Patricia Hughes
12 Connaught Street
Phibsborough
Dublin 7
D07 KF62

Re: CPO: Blanchardstown Bus Corridor, Case Reference: KA29N.313961

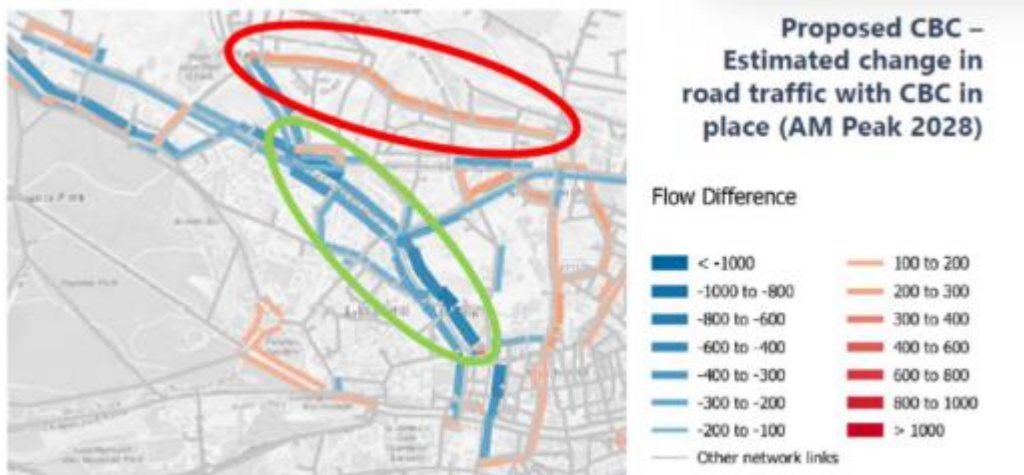
There are three road restriction changes proposed in the CPO application for the Blanchardstown Bus Corridor, none of which were set out in any of the proposed designs issued for public consultation since the Bus Connects project commenced in 2018.

The final preferred route was the result of three separate and rigorous stages of consultation since 2018 and yet none of the three proposed restrictions appeared in the [final preferred route](#) publication dated March 2022.

A number of changes were negotiated at a local level with residents' groups, in particular **Annamoe Road and Annamoe Terrace** (ref. BI) residents and their efforts to ensure their road does not become a "rat run," arising from the displaced traffic from the Old Cabra Road has meant significant changes to the original proposal which has dire consequences for our area. It is not clear why one resident's group would be successful in their endeavours to engage with the NTA to the severe detriment of another area such as mine.

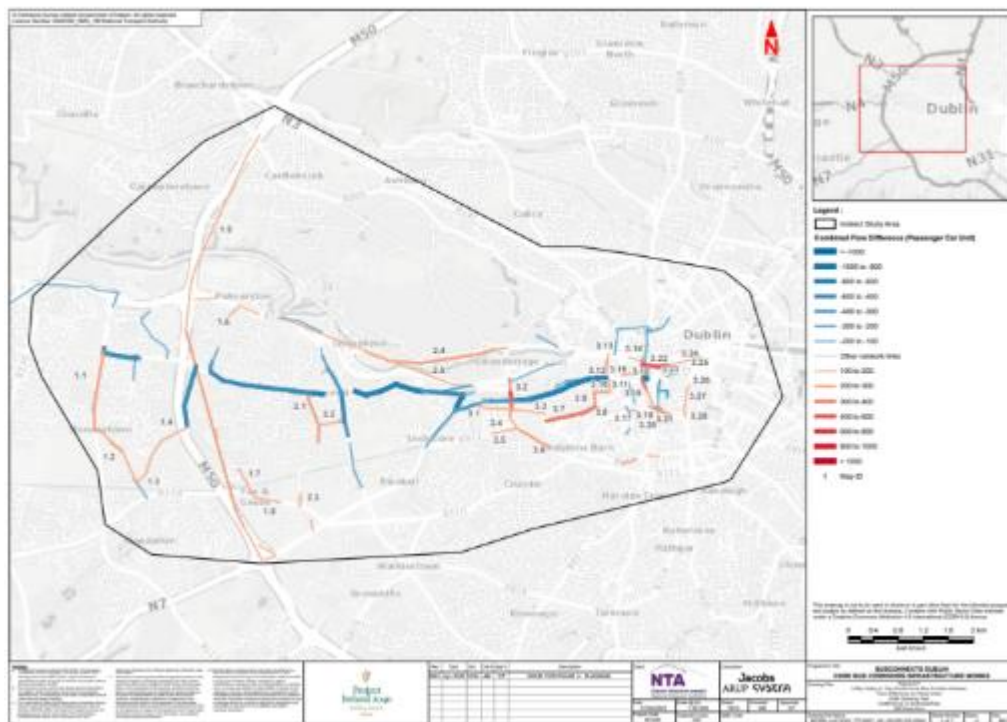
- **Flawed classification system of the impacts which sees areas forecast to experience an 80% increase in traffic flows being described as a “low impact” change.** In appendix A6.4 of the EIAR, Impact Assessments, the following are estimated when comparing a “Do Minimum” with a “Do Something” (i.e., BusConnects) scenario at PM peak hour:
 - An 80% increase in hourly traffic flows at the junction of Connaught Street and Shandon Crescent,
 - A 55% increase in hourly traffic flows at the junction of Fassaugh Ave and Dingle Road,
 - A 64% increase in hourly traffic flows at the junction of Fassaugh Ave and Bannow Road.

Each is described as having “not significant” effect and “negligible” impact. I can tell you as a resident of Connaught Street there is no way that changes of this nature can be considered “not significant” and “negligible” in their impacts on our abilities to go about our daily lives and live in a safe environment!

Furthermore, there is an estimated 70% increase in peak hourly traffic flows at the junction of Connaught Street and St Peter’s Road. This was described as being a “low impact” with “moderate” effect. It appears that only areas that are forecast to experience increases in traffic volume to beyond 85% of road capacity are classified as having any impact at all.
